FINAL PHASE I
CONTAMINATION ASSESSMENT REPORT
SITE 36-3: INSECTICIDE PIT
(Version 3.3)

Re: Rocky Mountain Arsenal (RMA),
Review of Final Phase I CAR Report for
Task 1, Site 36-3 Insecticide Pit

RESPONSES TO ENVIRONMENTAL PROTECTION AGENCY COMMENTS
ON THE FINAL TASK 1 REPORT
SITE 36-3: INSECTICIDE PIT

Figure 36-3-6
PHASE I INVESTIGATION,
BORING LOCATION MAP,
SITE 36-3

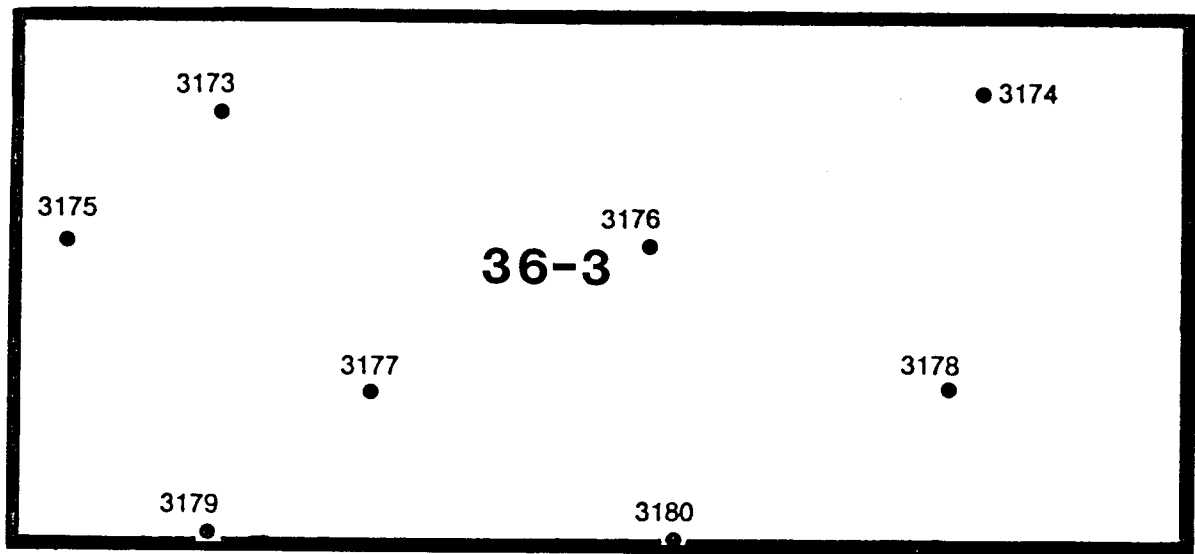
Figure 36.3-6 [sic] should show the location of trenches based on aerial photos.

The trench locations were not placed on the figure due to the complex nature of the site which made such a presentation confusing and potentially misleading. The geophysical investigation generally detected high response levels and intense anomalies, such that it was very difficult to delineate trench and intertrench material. Maps presented in the geophysical report display these results, and explain that no direct correlation between trenches indicated on aerial photographs and geophysical anomalies was possible due to these uncertainties. The proposed investigation of suspected trench locations is based on the chemical and geophysical data. Further attempts to map trench locations will be made when additional data is gathered through Phase II borings.

Figure 36-3-7
PHASE I INVESTIGATION,
CHEMICAL ANALYSIS
RESULTS, SITE 36-3
SOURCE: ESE, 1987

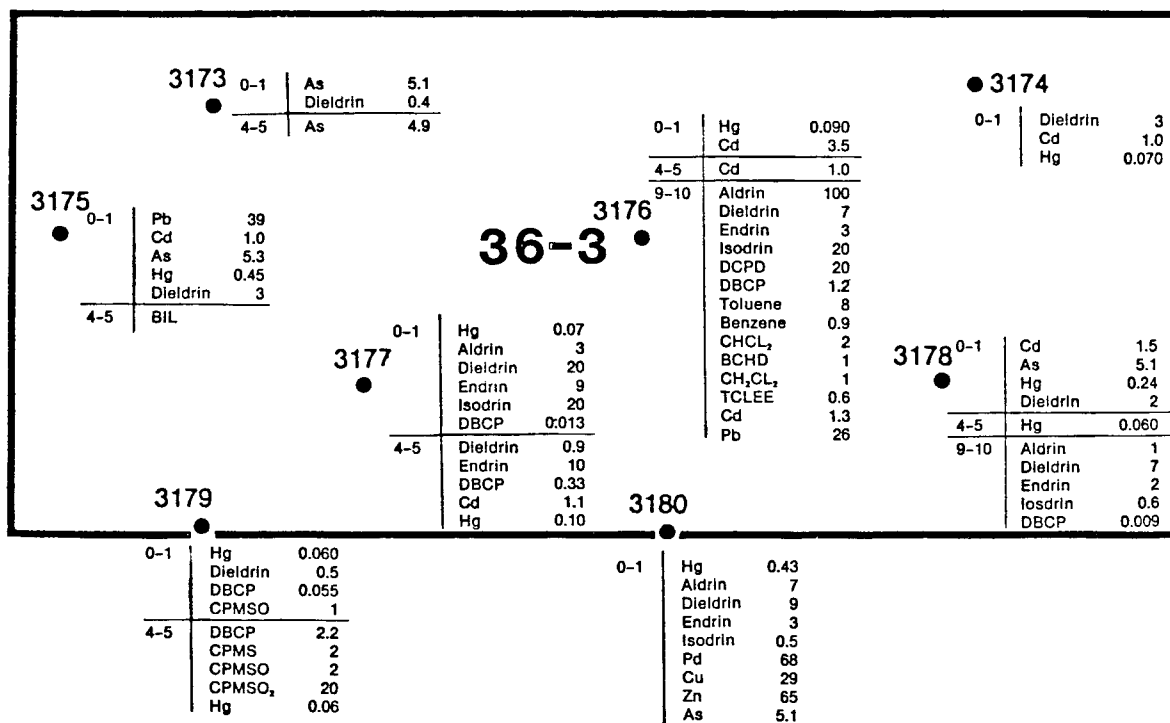
7. P. 36-3-22 Figure 36-3-10 should be corrected to show contaminants at or in excess of the revised indicator levels for metals.
8. P. 36-3-20 Table 36-3-3 should differentiate when samples are not analyzed for a particular class of organic chemicals such as volatiles.

7. 36-3-22 The figure has been revised as requested and now shows values within or above the established indicator ranges.
8. 36-3-20 The table has been revised as requested to clearly indicate when samples were not analyzed and when analysis was performed but no detections were made.
